ADDENDUM No. 1

ITB No. 4459

Gallup Park Universal Access Playground Construction

**ROTARY CLUB OF ANN
ARBOR CENTENNIAL
PLAYGROUND**

DRAWING TITLE
SITE REMOVALS AND SESC PLAN

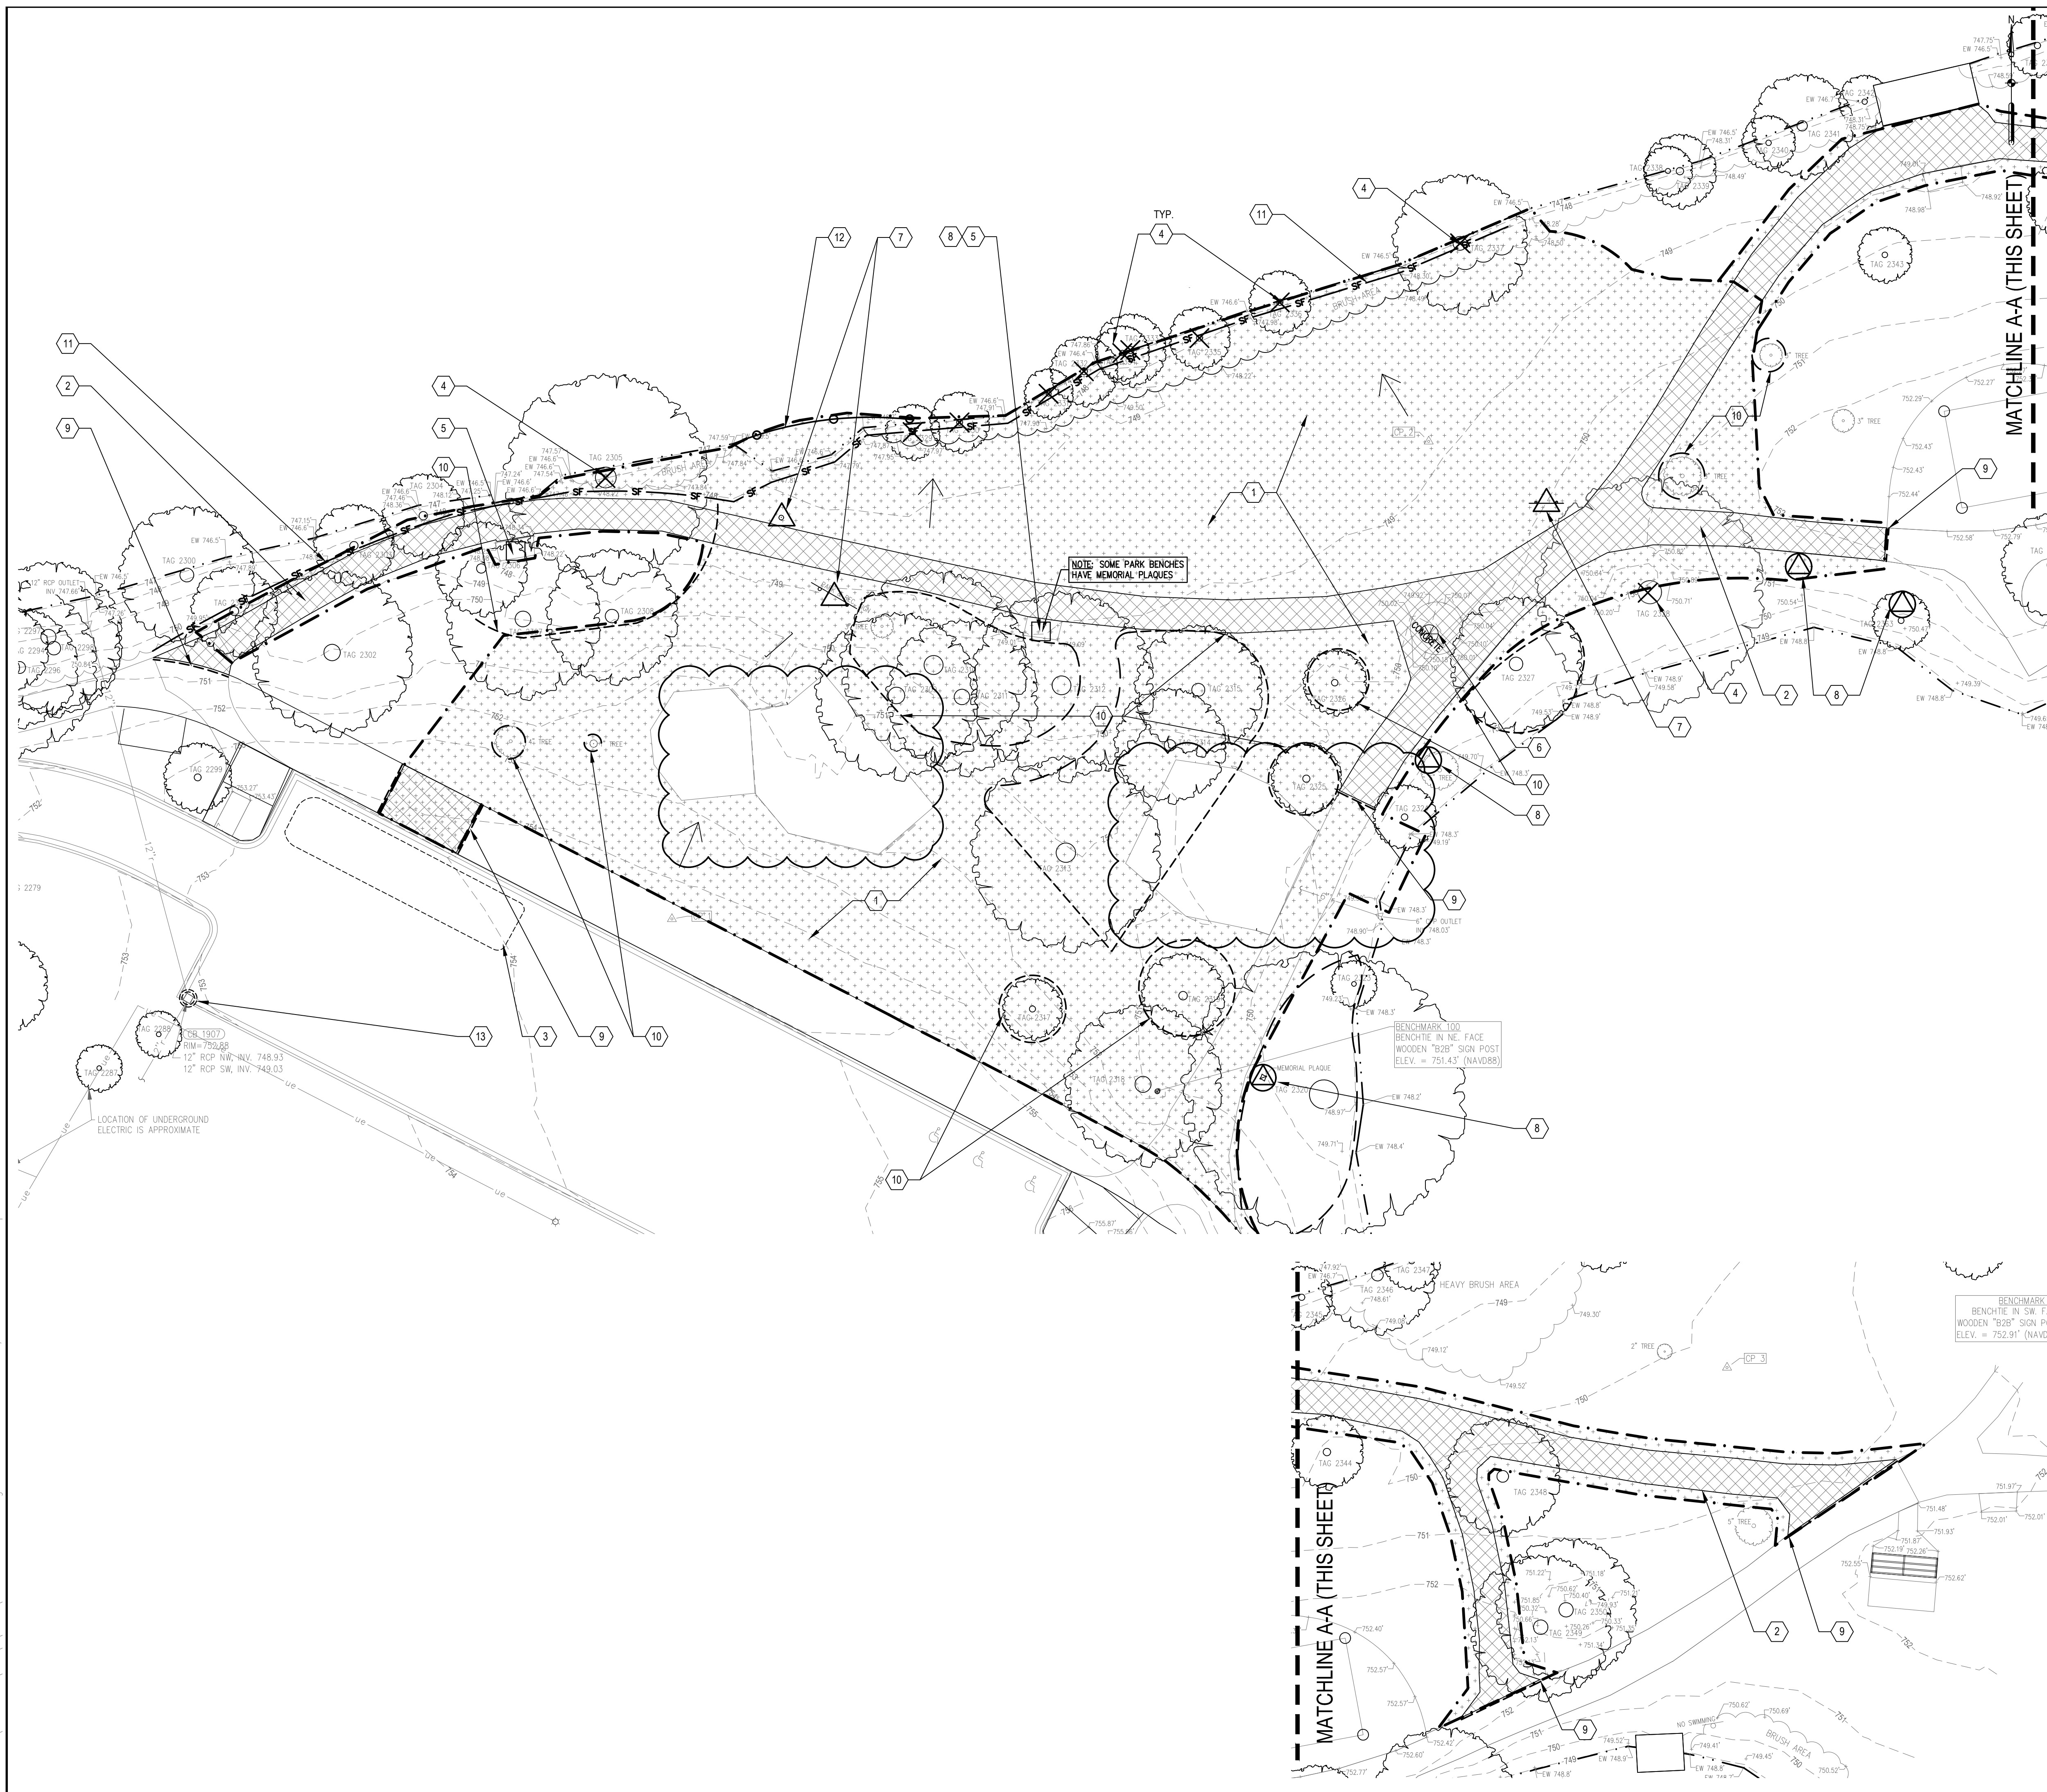
Answer 7: All removals shown on sheet L1.0 should be included in line item #3, Earthwork and grading, including asphalt path removal, as well as benches, plaques and signs. All vegetation removal should be included in item #4, Shoreline vegetation removal complete.
